To: Plan Holders for SLN Terminal Expansion  
Salina Regional Airport  
Salina, KS  
AIP Project Number 2-20-0072-054/055-2024

Transmitted herewith Addendum No.2 to the Issued for Bid Contract Documents, Specifications and Plans dated July 2, 2024 for improvements to the Salina Regional Airport.

**ADDENDUM NO. 3**  
**TO**  
**CONTRACT DOCUMENTS, TECHNICAL SPECIFICATIONS, AND**  
**PLANS**  
**FOR IMPROVEMENTS TO THE**  
**SALINA REGIONAL AIRPORT**  
**SALINA, KS**  
**AIP PROJECT NUMBER 2-20-0072-054/055-2024**

SHEET NO:  
**G-055**

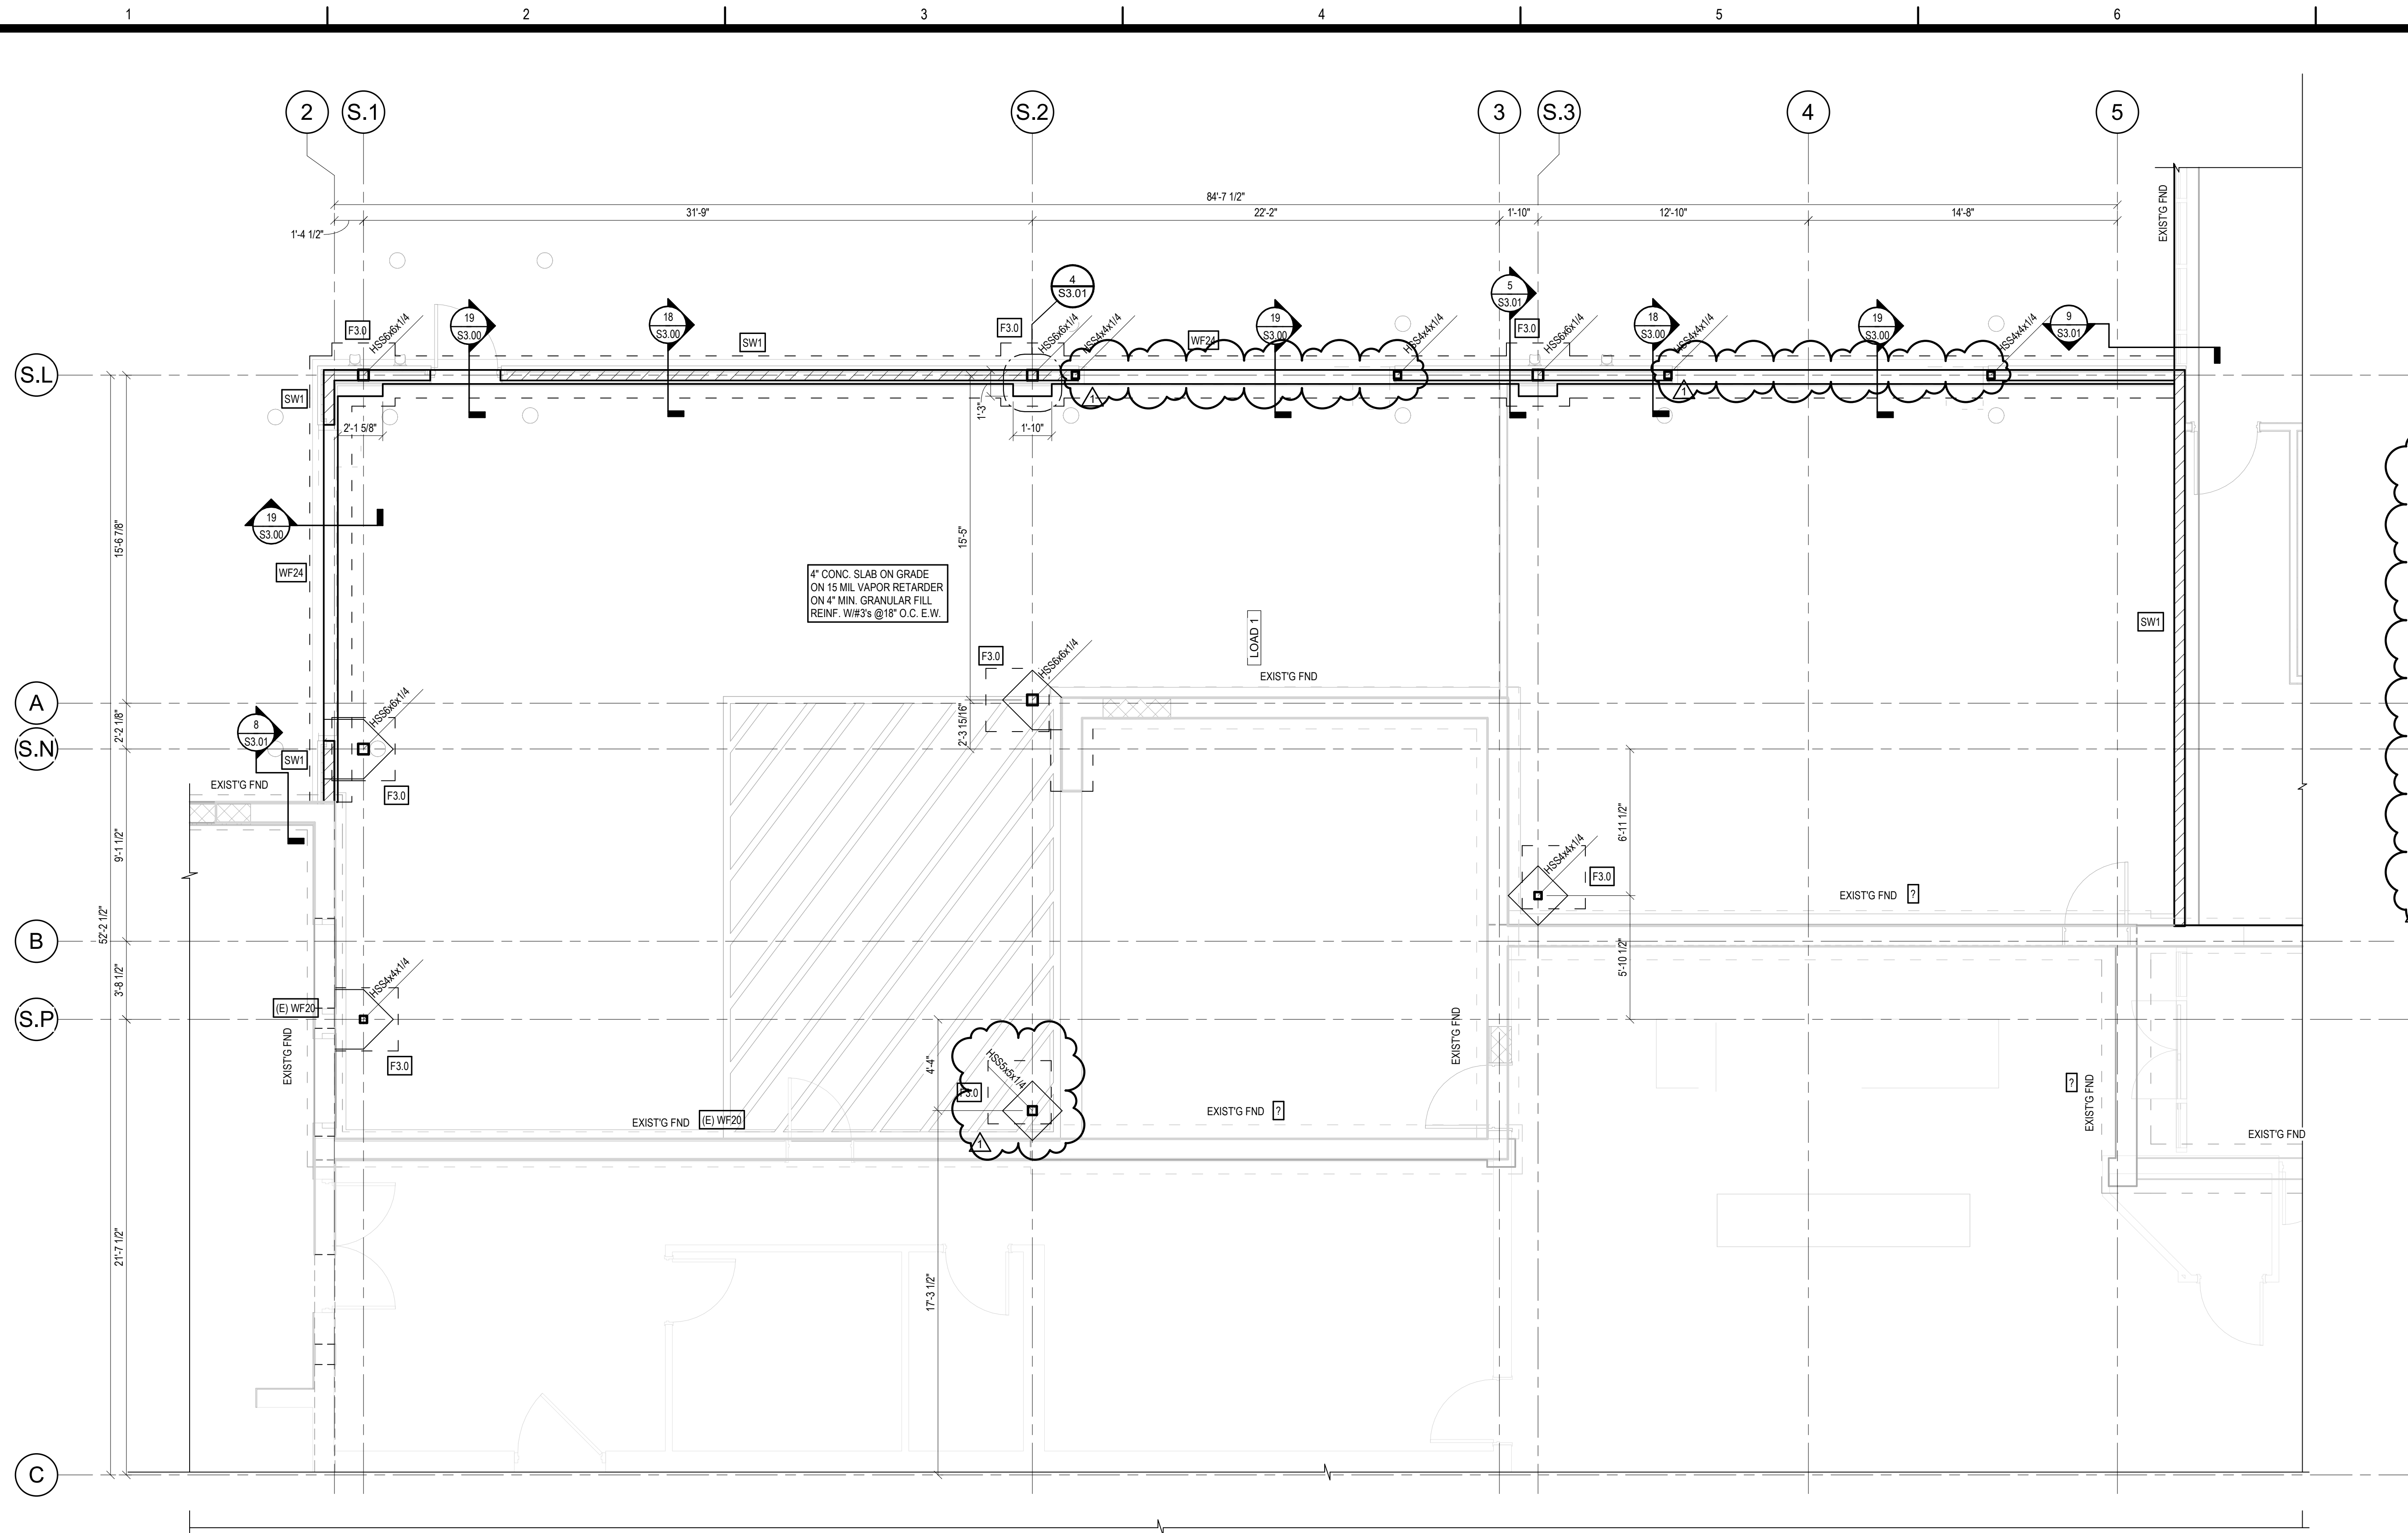
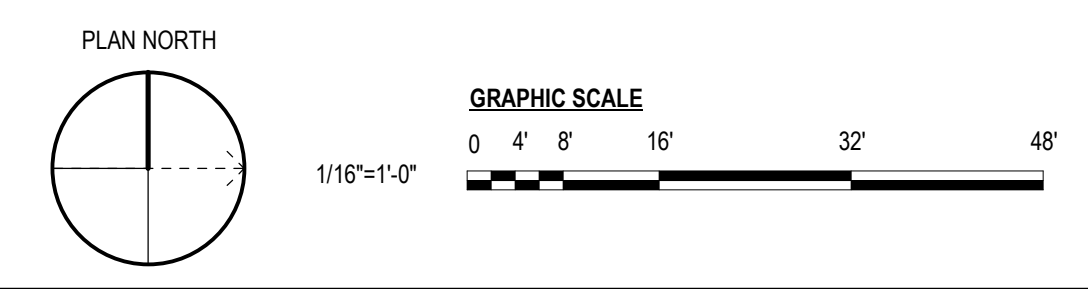
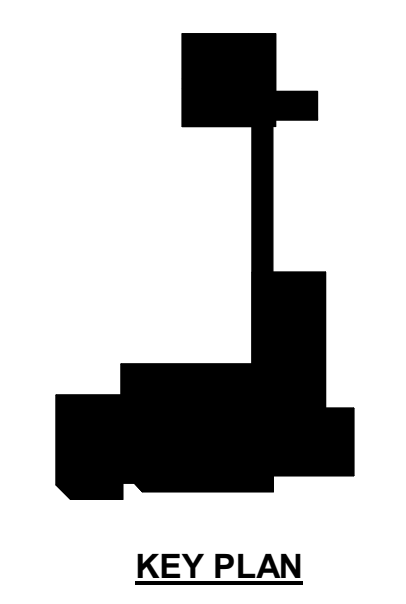
**G055 CONSTRUCTION SCHEDULE 2 / PHASE 2 NOTES**

**Justification:** For clarification.

4. SCHEDULE 2 DEFINED WORK: All exterior façade work to be included in Schedule 2 work. Refer to revised plan. Sheet G-055 has been revised to include the exterior façade work. Also, refer to A-203.
5. SCHEDULE 1 DEFINED WORK: The Airport has decided to have Door 106, previously noted as temporary and to be removed, to remain at the completion of construction. The walkway noted as temporary is also to remain after construction. Refer to Floor Plan and Door Schedule for further information.

SHEET NO:  
**S2.01**

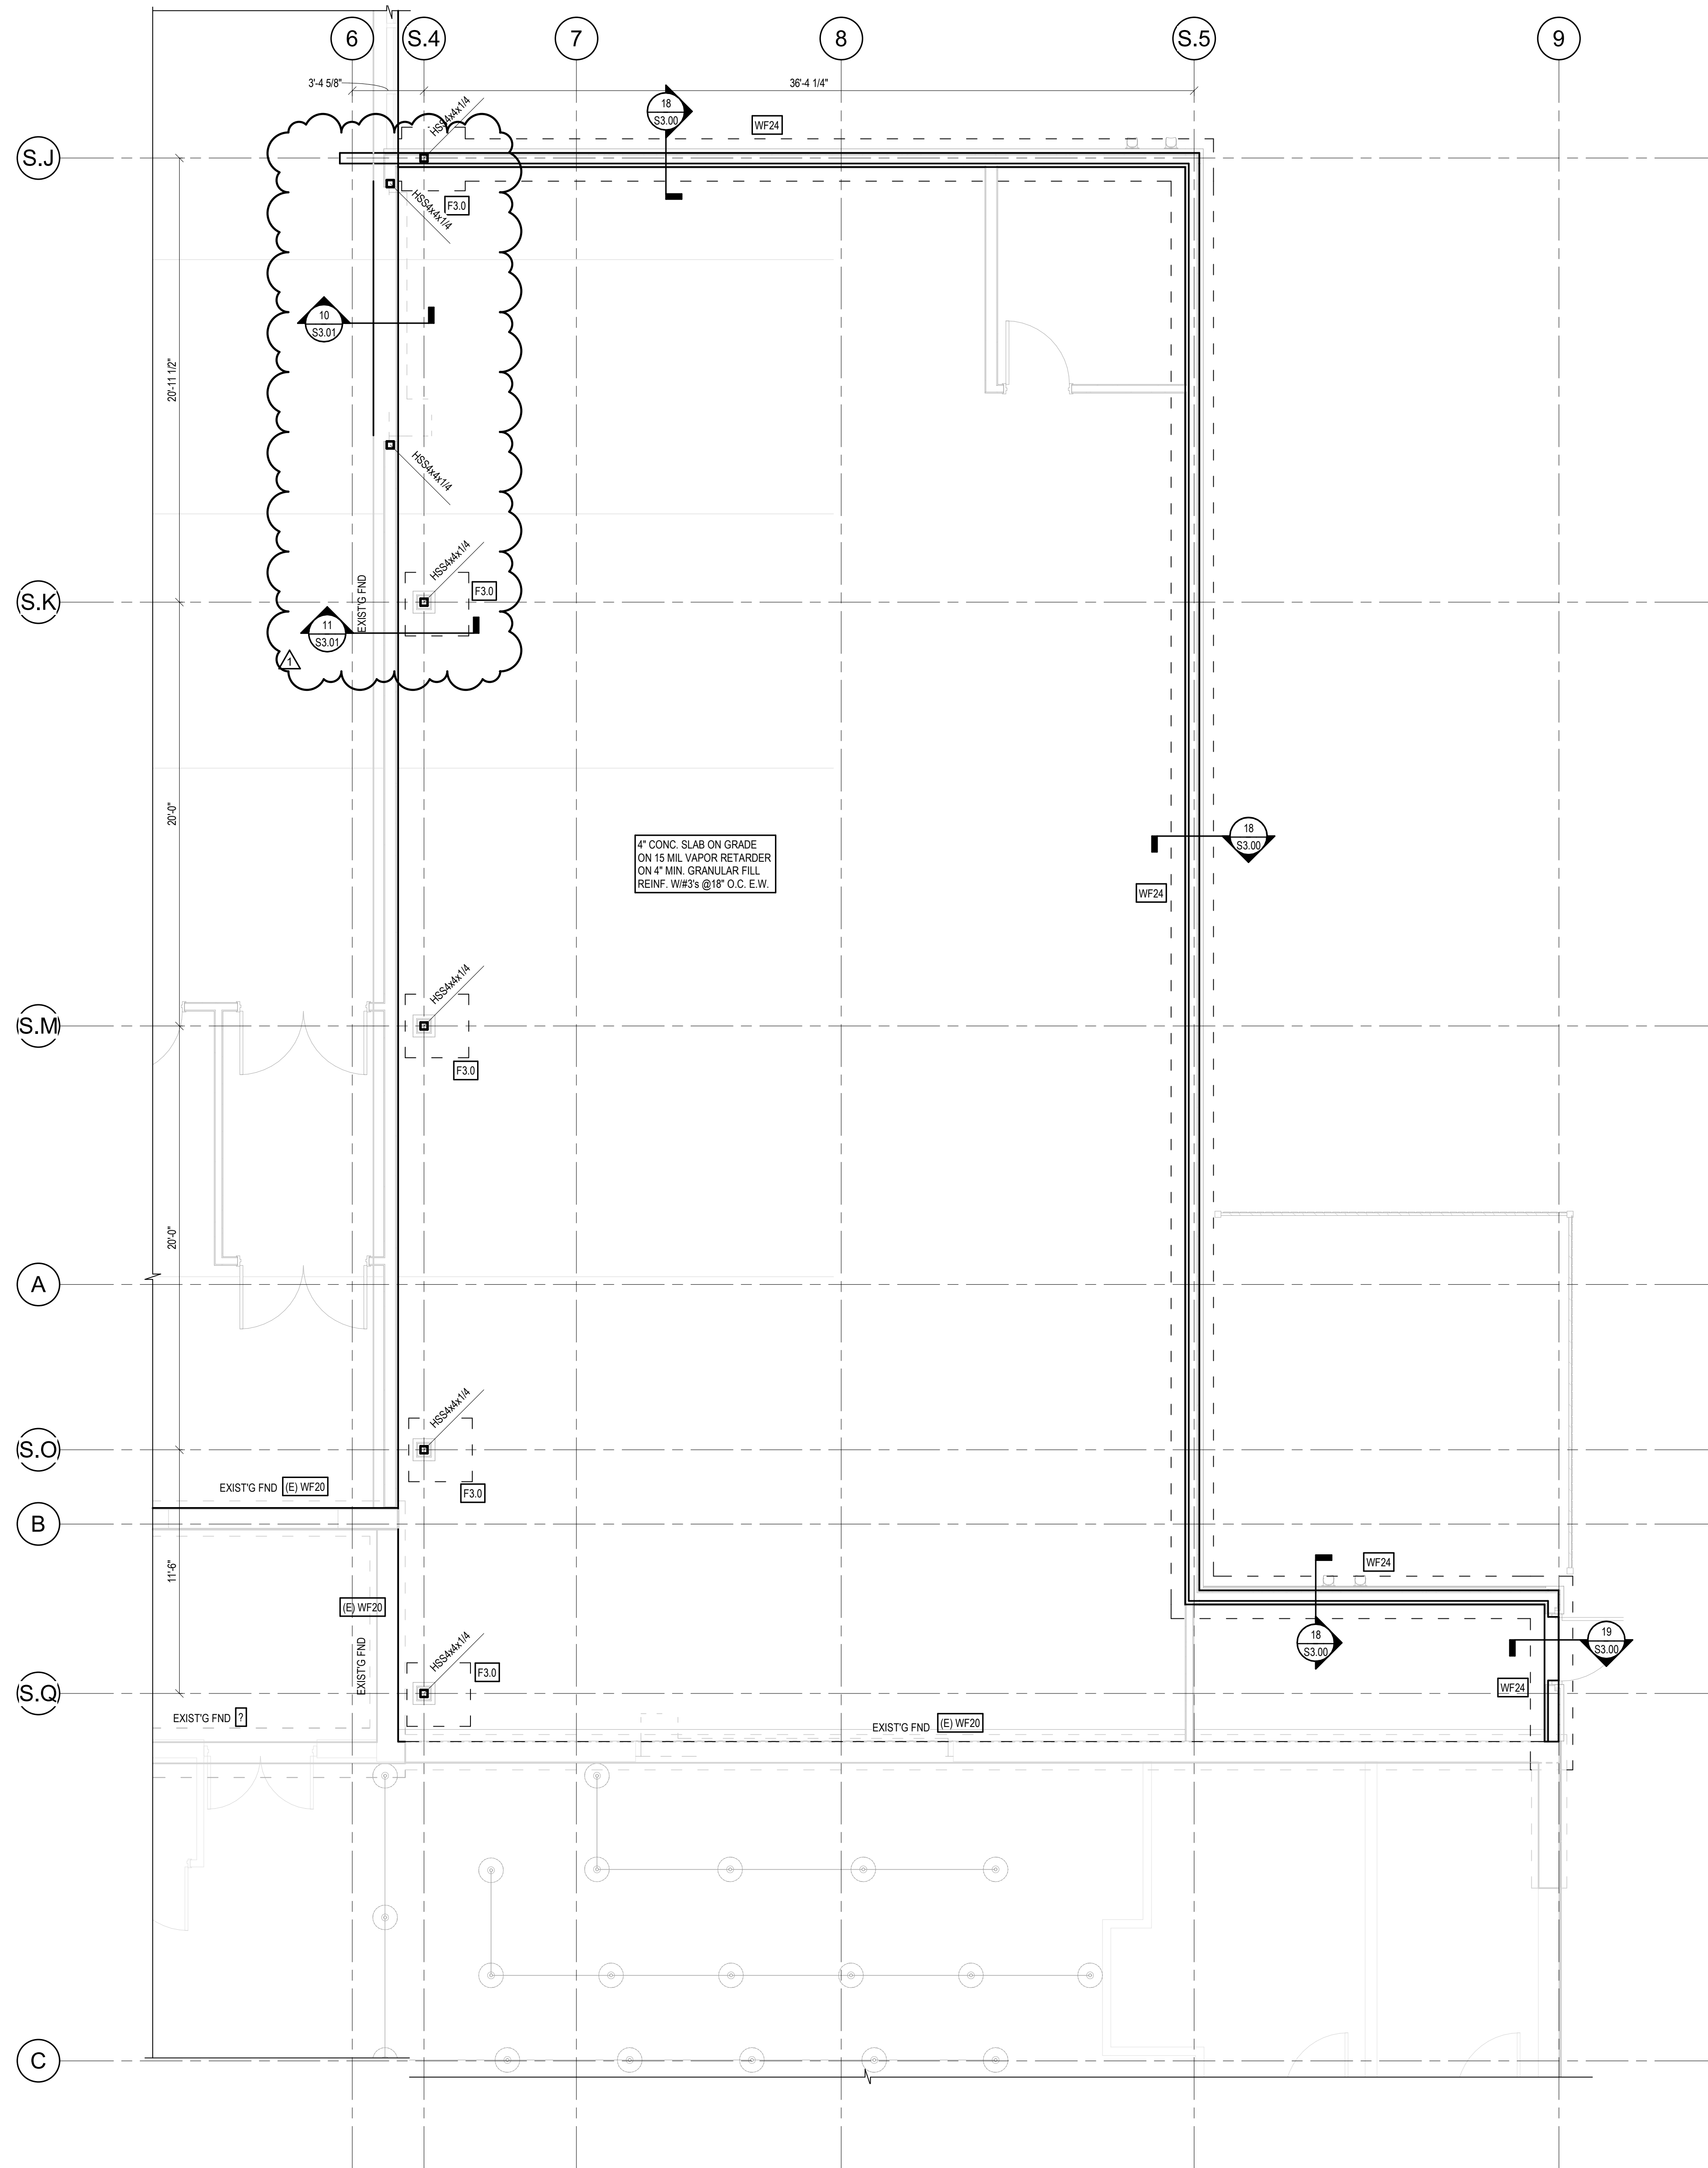
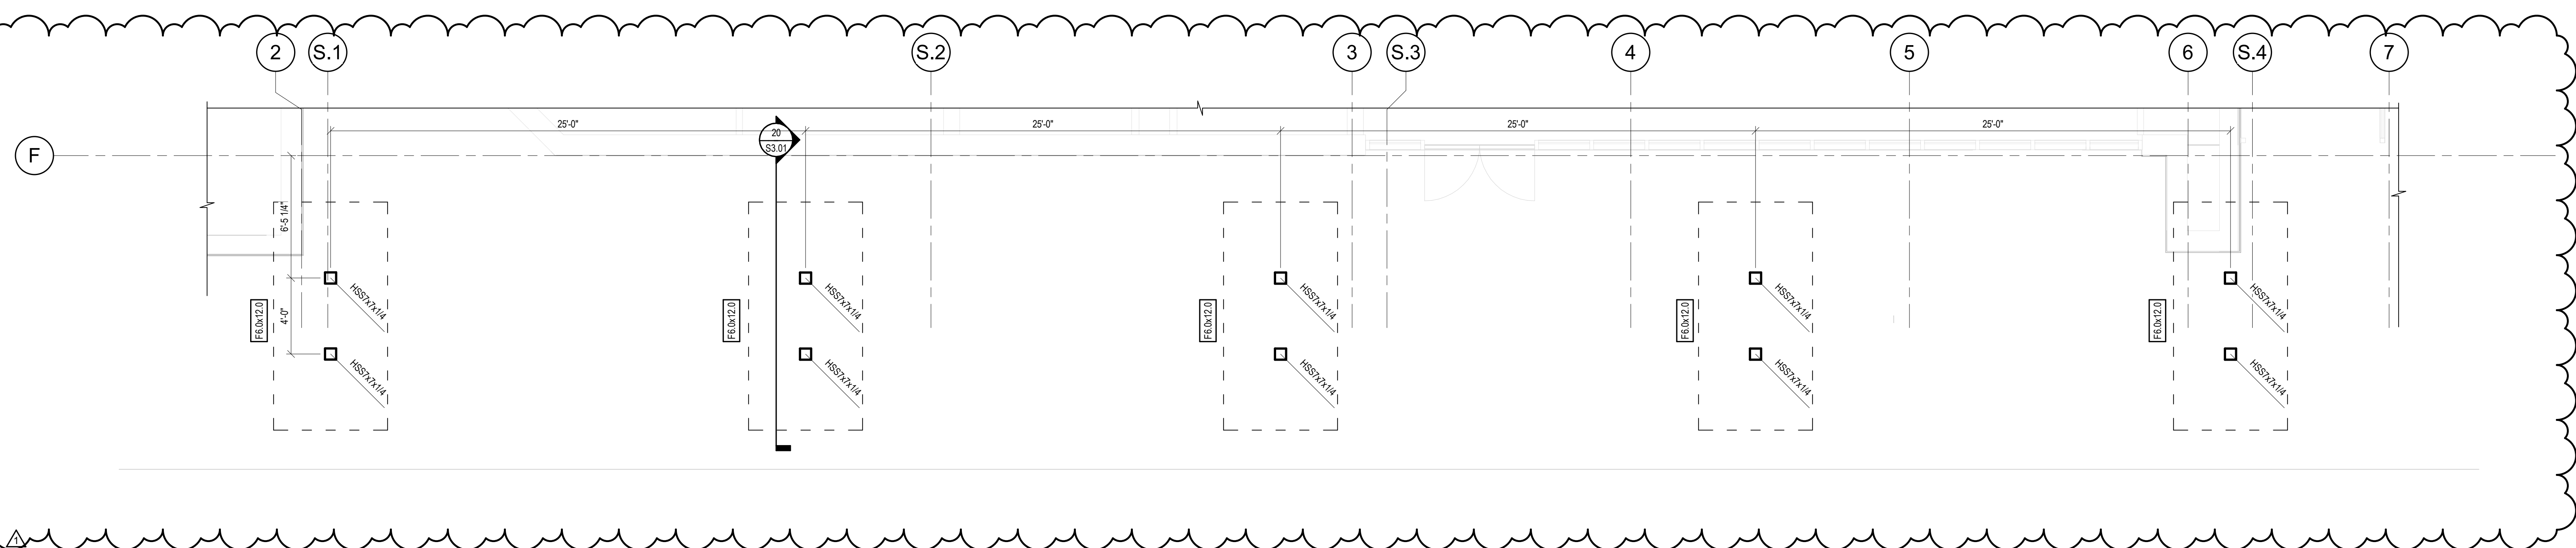
**S201 BAGGAGE FOUNDATION PLAN**

**Justification:** For clarification of footings.

8. *Footing schedule is missing from the plans. Can this please be provided?*  
**RESPONSE:** Please see the added Footing Schedule on Structural Sheets.
